**Before the Decision Makers appointed by the
Canterbury Regional Council**

IN THE MATTER OF Application CRC242267,
CRC242268, CRC242269 and
CRC251999 by Christchurch
City Council for a land use (s9)
consent to use land for
earthworks and vegetation
clearance within 10m of a
natural inland wetland; For a
coastal permit (s12) to disturb
the foreshore and seabed, to
deposit material on the
foreshore and seabed, to erect
a structure, to occupy the
Coastal Marine Area and to
reclaim the Coastal Marine
Area; For a discharge permit
(s15) to discharge construction
phase stormwater within 10m
of a natural inland wetland and
to discharge contaminants to
land; and For a discharge
permit (s15) to discharge
contaminants to air.

Section 42A Officer's Report

Date of Report: 11 November 2025

Figure 4: Inundation Bund Design

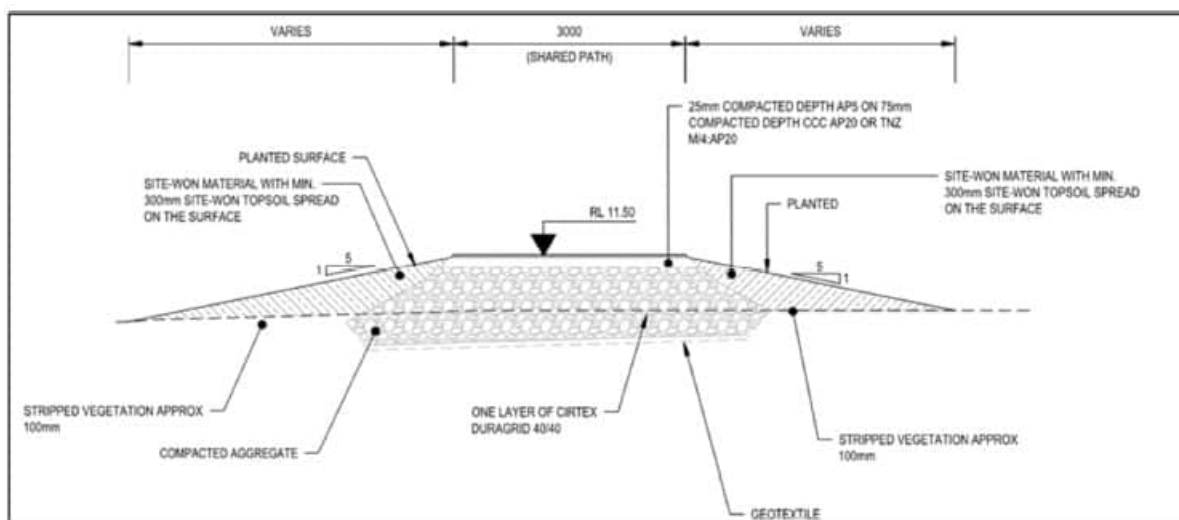
209. Prior to the notification of the application, Mr Gabites had considered that the inundation bund design and location could be amended and still provide a consistent level of inundation protection to the community. He also noted that a cobble beach would be sufficient protection for Southshore as opposed to the proposed rock revetment, with also space for coastal erosion to generally occur without impacting on any properties or pieces of significant infrastructure or requiring reclamation or further encroachment into the estuary bed.

212. Mr Gabites however states that he disagrees with the applicant as no allowance for increased water levels due to sea level rise or other climate change impacts or changes in ground elevations were included in the design process. Further, it is his opinion that the proposed height of the inundation bund of 11.5 m CDD will provide protection from the estuary water level events between 500 and 1000 years without taking into account the impacts of climate change or local land changes.

Figure 9: Cross section for 44a Rocking Horse Road

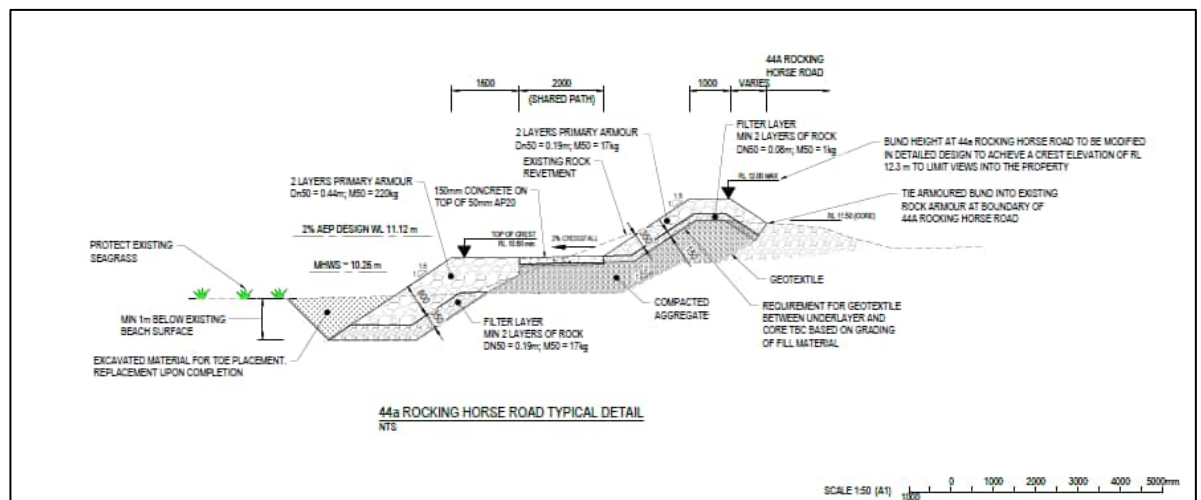
It is noted that the recent iteration of the design for the Project (see Jacobs Sheet 2005) includes a 200 mm increase in the height of the bund opposite 44a. This height increase is to reduce public views into this property from the shared path. In turn, this will also cause slightly more screening to estuary views for any occupants of 44a, however a 200 mm height increase balanced with improved privacy for this party and the other landscape improvements is not considered substantial enough to alter the effects finding in the author's opinion.
